**Town of Duanesburg
Zoning Board of Appeals
August 16th, 2022**

PROPOSED SITE PLAN FOR
OAK HILL SOLAR 1&2
APPLICANT:
OAK HILL SOLAR 1, LLC & OAK HILL SOLAR 2, LLC
13950 DUANESBURG ROAD
TOWN OF DUANESBURG, SCHENECTADY COUNTY, NEW YORK

Exhibit B Biggs/Bruning to Zoning Board June 20, 2022

2-254-66
 506'20"0"E
 MATCHLINE SHEET 4
 MATCHLINE SHEET 3

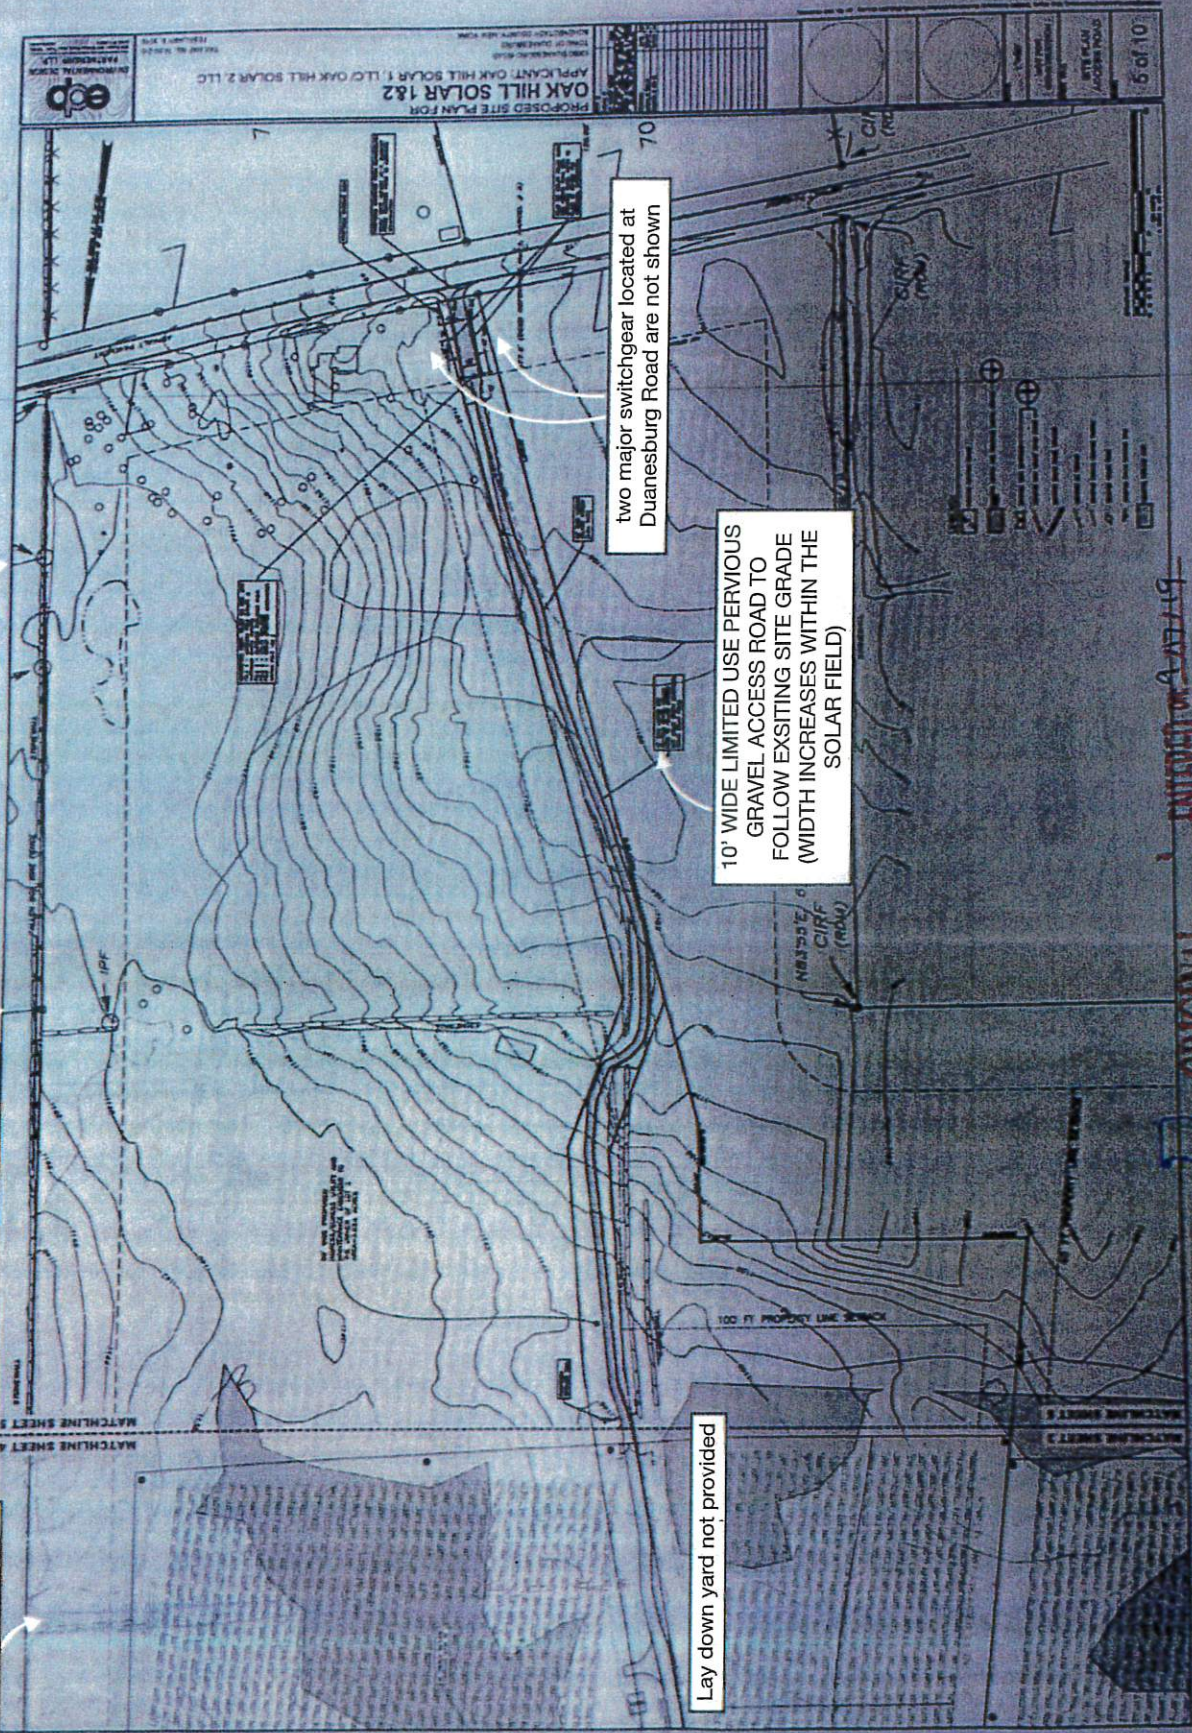
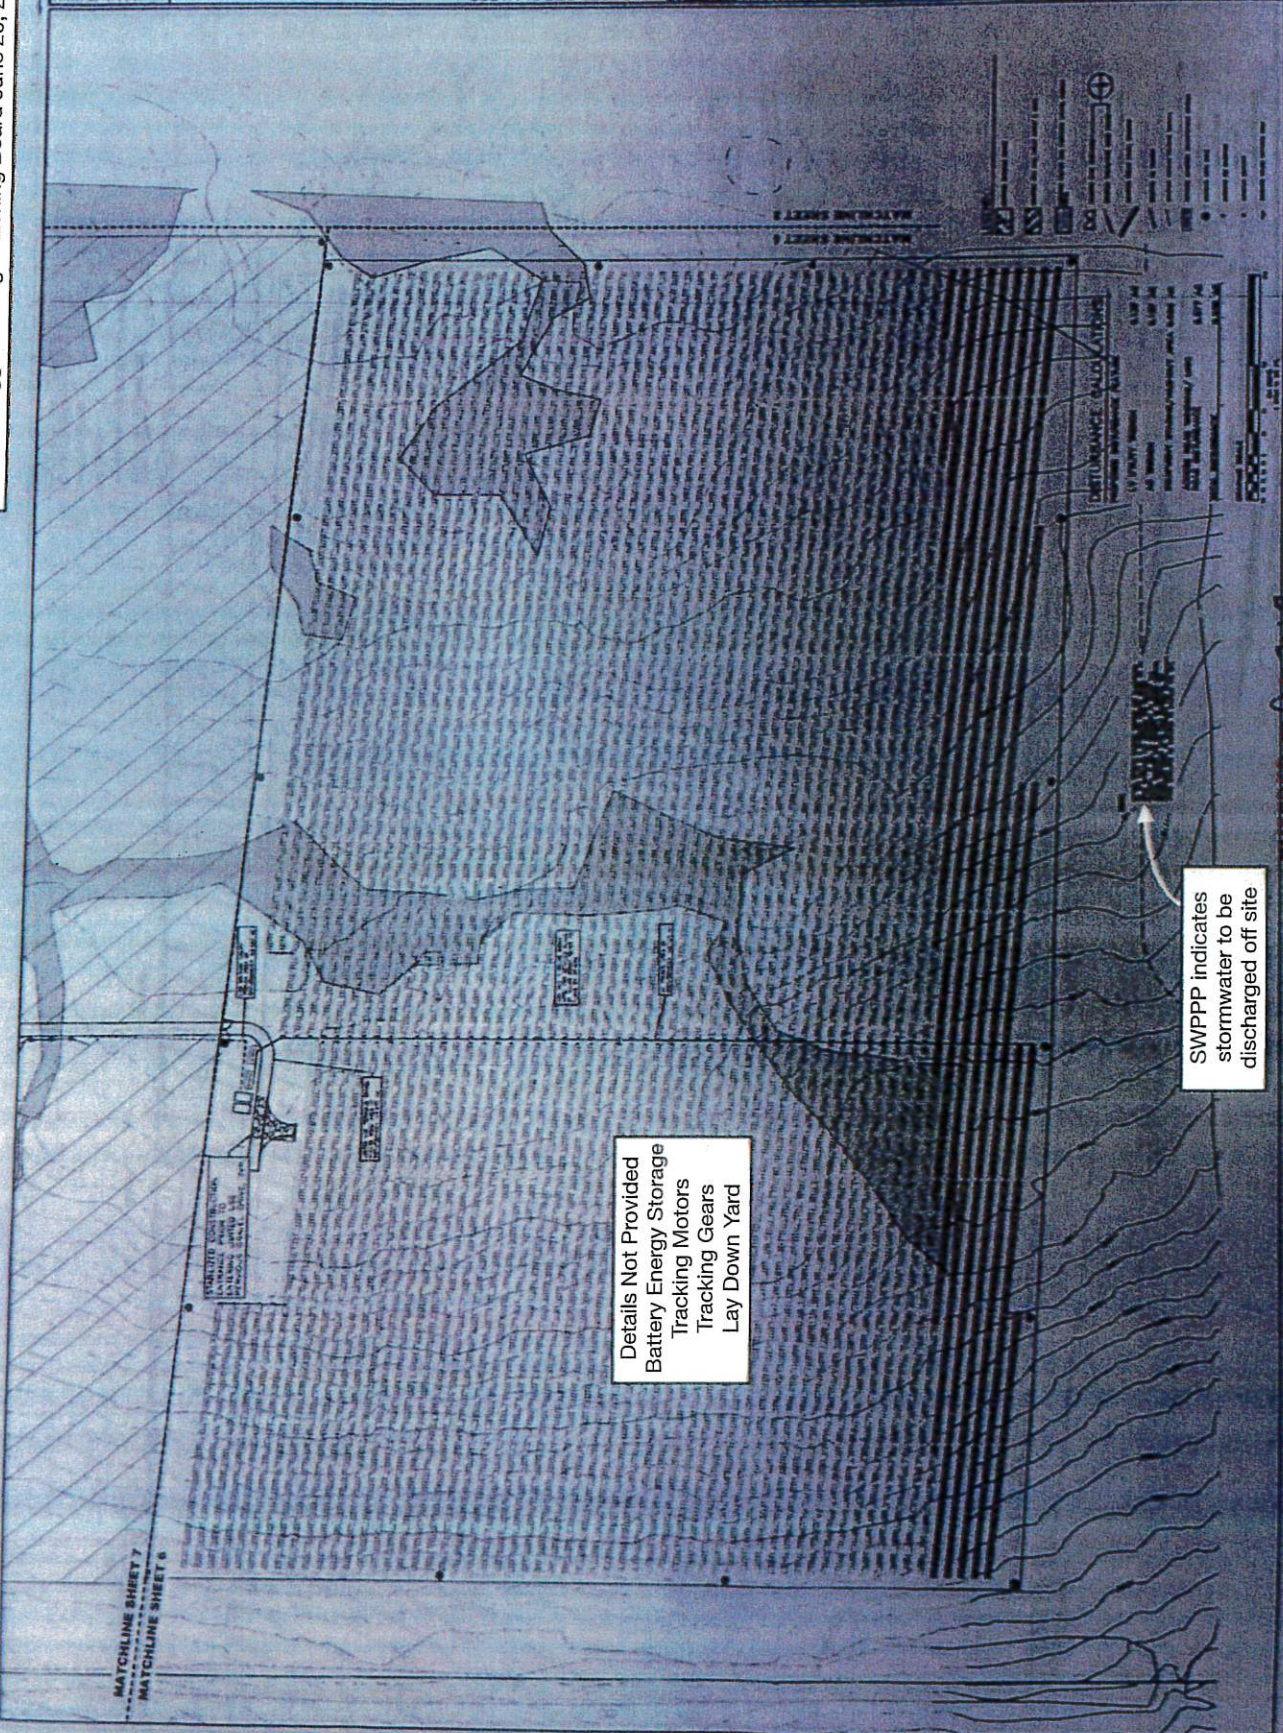
300' north of Duanesburg Road

800' north of Duanesburg Road

1,500' north of Duanesburg Road

Lay down yard not provided

Details Not Provided
 Battery Energy Storage
 Tracking Motors
 Tracking Gears
 Lay Down Yard

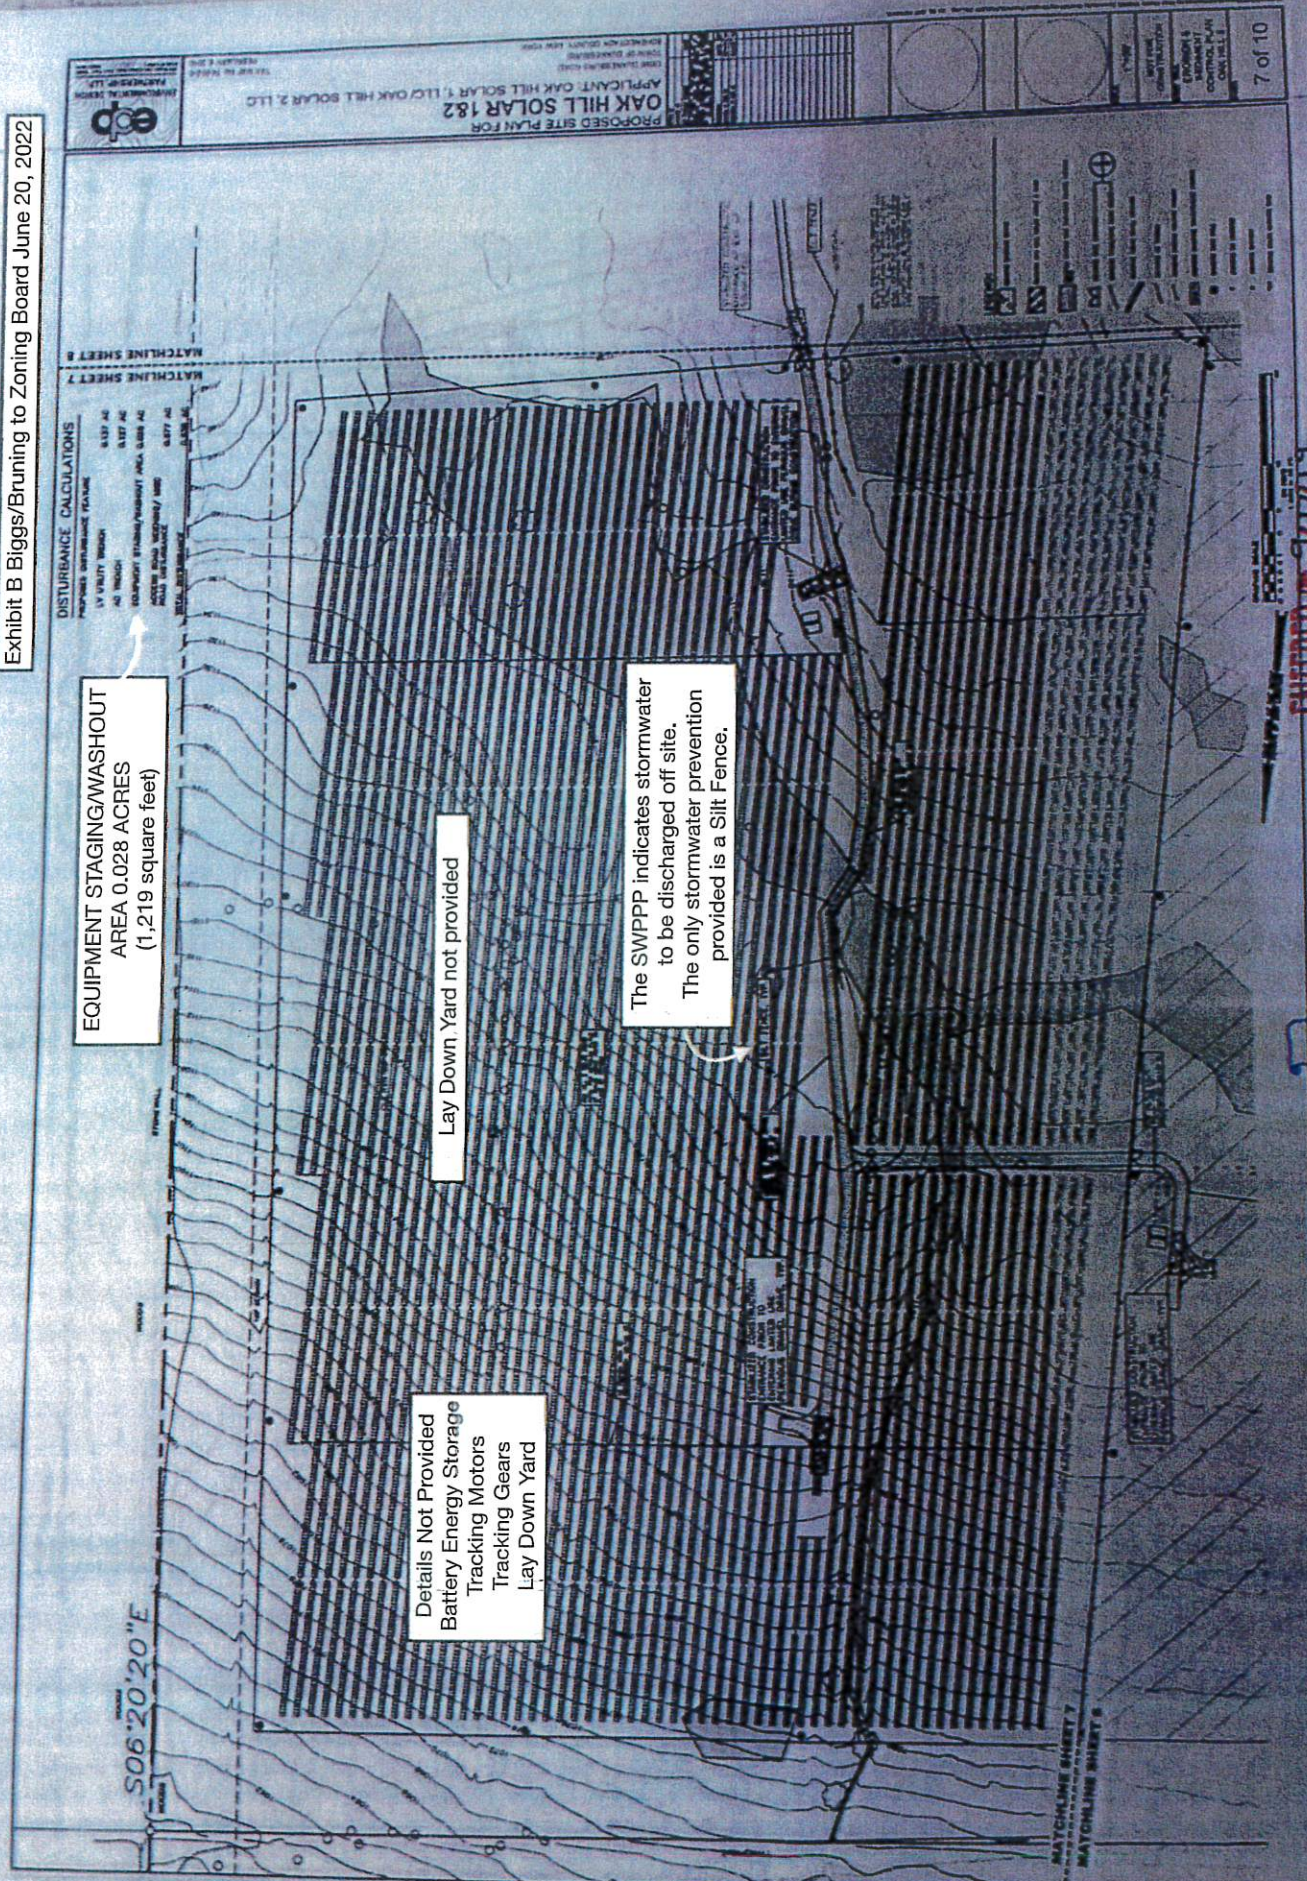
Details Not Provided
Battery Energy Storage
Tracking Motors
Tracking Gears
Lay Down Yard

Lay Down Yard not provided

The SWPPP indicates stormwater
to be discharged off site.
The only stormwater prevention
provided is a Silt Fence.

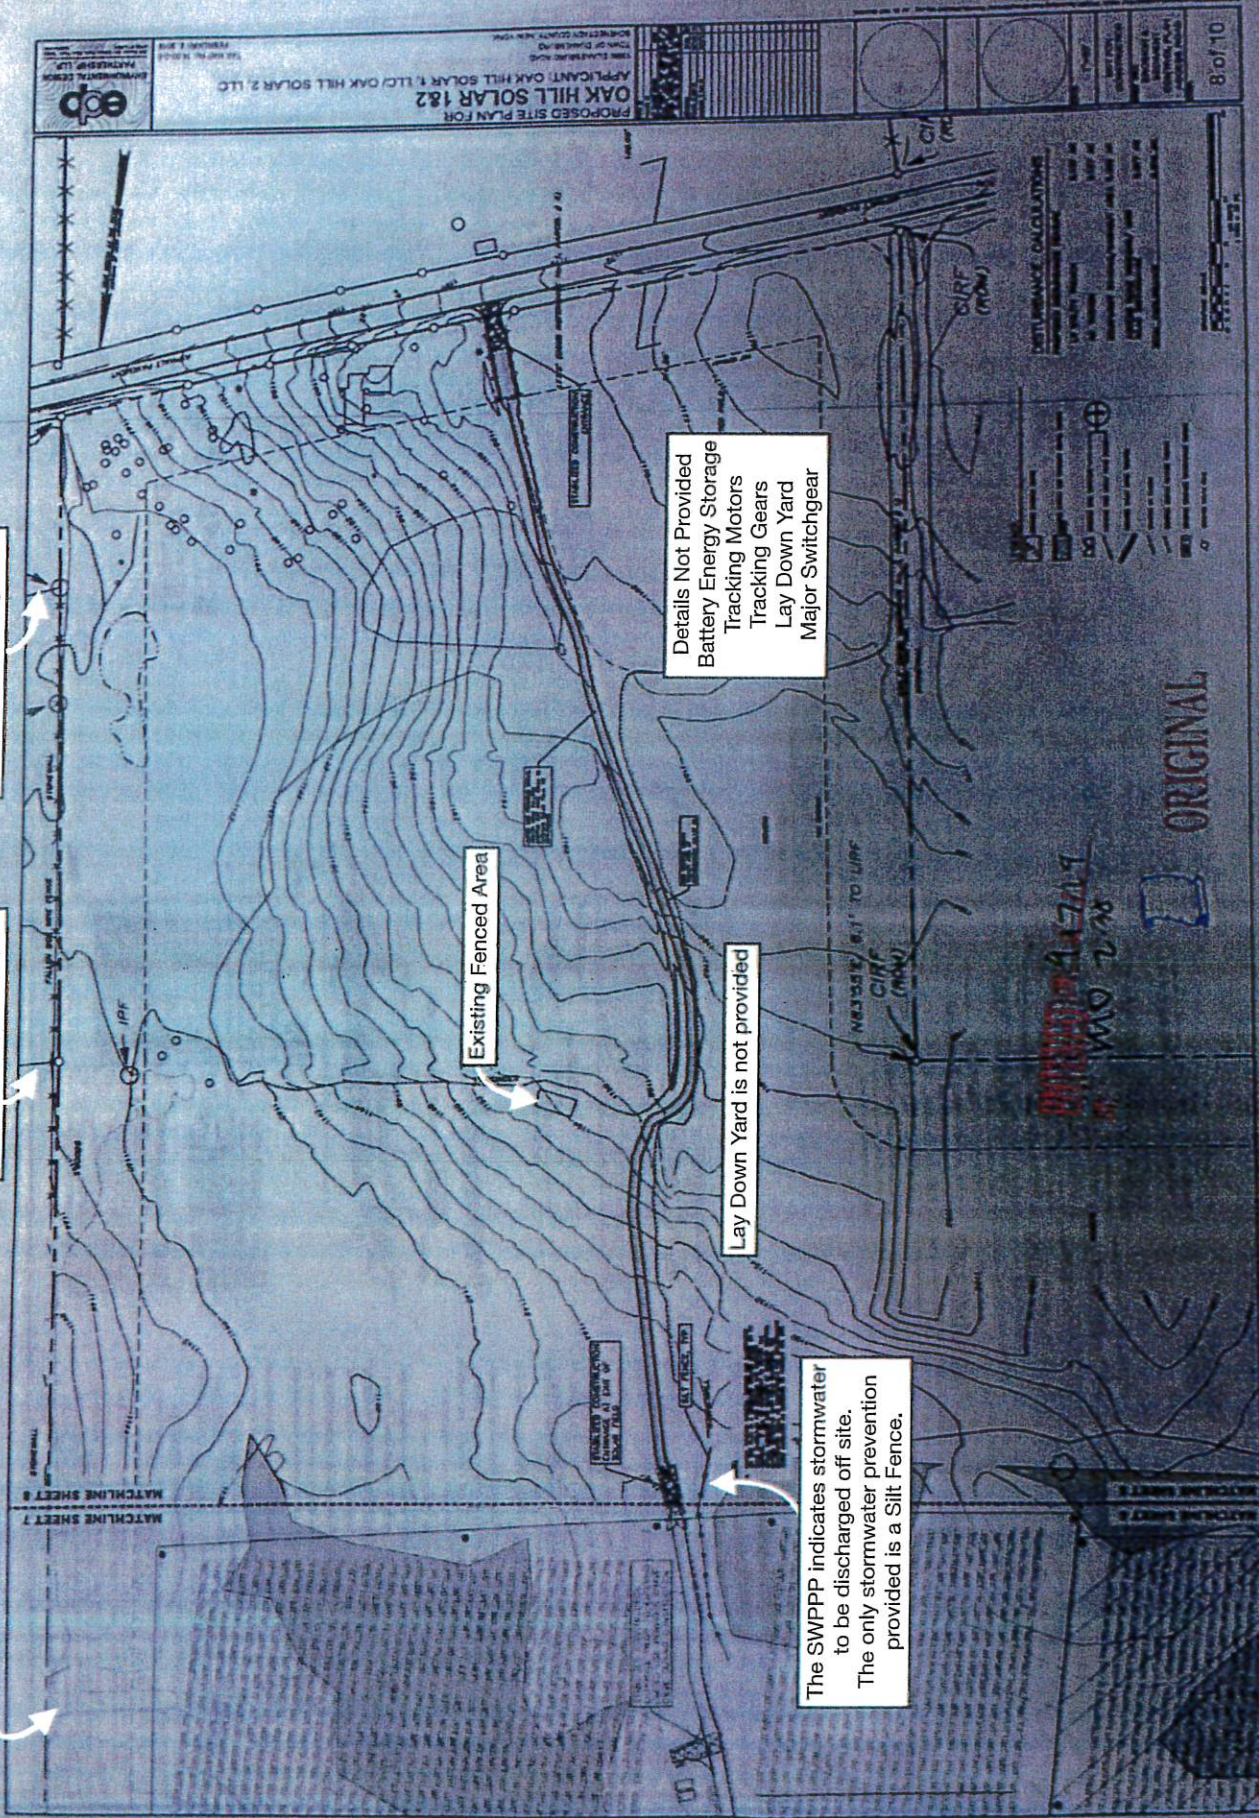
300' north of Duanesburg Road

Six feet in height fence.
